March 4, 2026

Development Review Committee Staff Comments

Bruin Road District PUD (PUD Master Plan): A request by Kurt's Investments, LLC, for review of a Planned Unit Development (PUD) Master Plan application. The Applicant proposes a mixed-use development with associated infrastructure. The property is currently zoned Neighborhood Core-Historic District (NC-HD), Residential General (RG), and Neighborhood General-Historic District (NG-HD) and consists of approximately 7.26 acres identified by tax map numbers R610 039 00A 0024 0000, R610 039 00A 030B 0000, R610 039 00A 0030 0000, R610 039 00A 0048 0000, R610 039 00A 0026 0000, R610 039 00A 0027 0000, R610 039 00A 0029 0000, R610 039 00A 030D 0000, R610 044 000 0126 0000 located east of Bluffton Road north of Bruin Road. (MP-01-26-020087) (Staff - Dan Frazier)

Exhibit G (Transportation Impact Analysis) needs additional review and discussion.

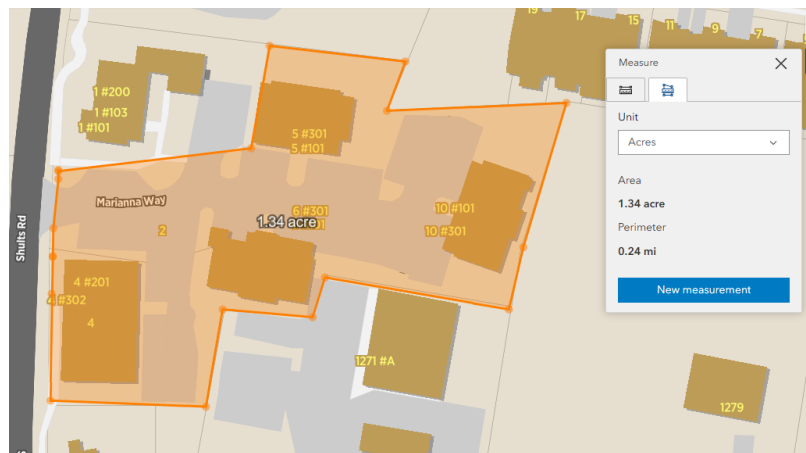
- a. No information is provided as to how the applicant came to a conclusion as to what is currently allowed in each district.
- b. The Traffic Consultant used a by-right count based on the site being able to accommodate 100 Multi-Family Units, 10,000 SF of Retail/Shops, 10,000 SF of Restaurant, 25,000 SF of General Office, 18 Single Family Residents and 18 Short Term Rental Units.

- c. The total project is 7.29 acres, of that 5.429 acres are zoned Residential General or roughly 74.4% of the site. Neighborhood Core-HD – 1.34 Acres = 18.3% of the Project & Neighborhood General-HD – 1.13 Acres = 15.5% of the Project. Based on the acreage **Staff believe that there could only be roughly 7,000 SF of Commercial and roughly 40 RDUs in the Historic District and 21 RDUs in the Residential General zoning district.**

- i. Staff came to this conclusion by using a similarly sized development, Old Village Square. Old Village Sq. 1.34 acres – 4 buildings, 1k sf retail and 5 units per building.)

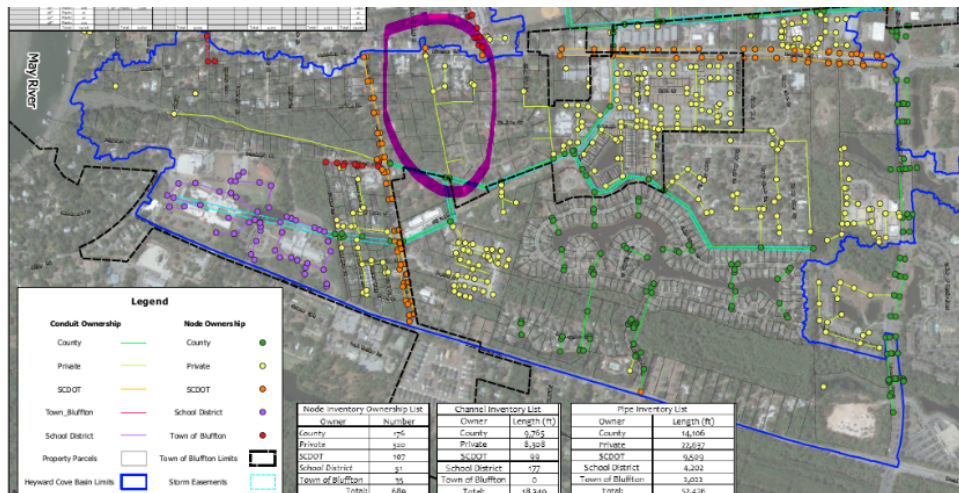
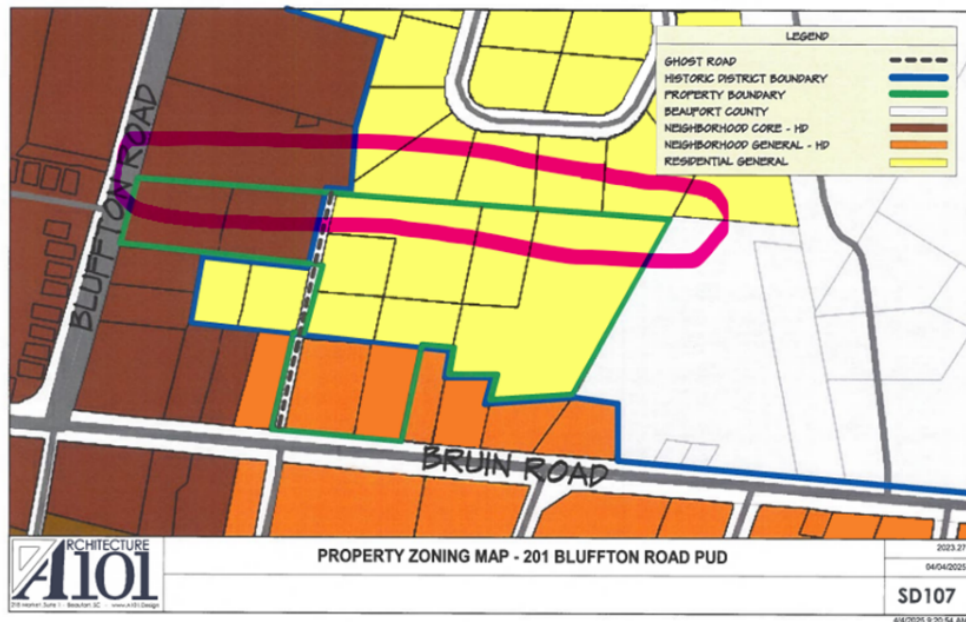
- d. The TIA needs to be updated to reflect actual by-right entitlements to accurately assess the impact of the proposed development request. Staff

does not agree with the TIA's By-Right assumptions included in the Project Trip Generation Summary.

- e. The TIA states that there is an assumption of a 48% internal capture rate. Please show where this is an acceptable amount. Typically you could estimate anywhere between 10-30%. Even at 30% that is for high-intensity mixed-use, which this is not.
- f. **TIA will be reassessed with Staff, our consultant and SCDOT to determine if improvements are needed as a result of the new document.**
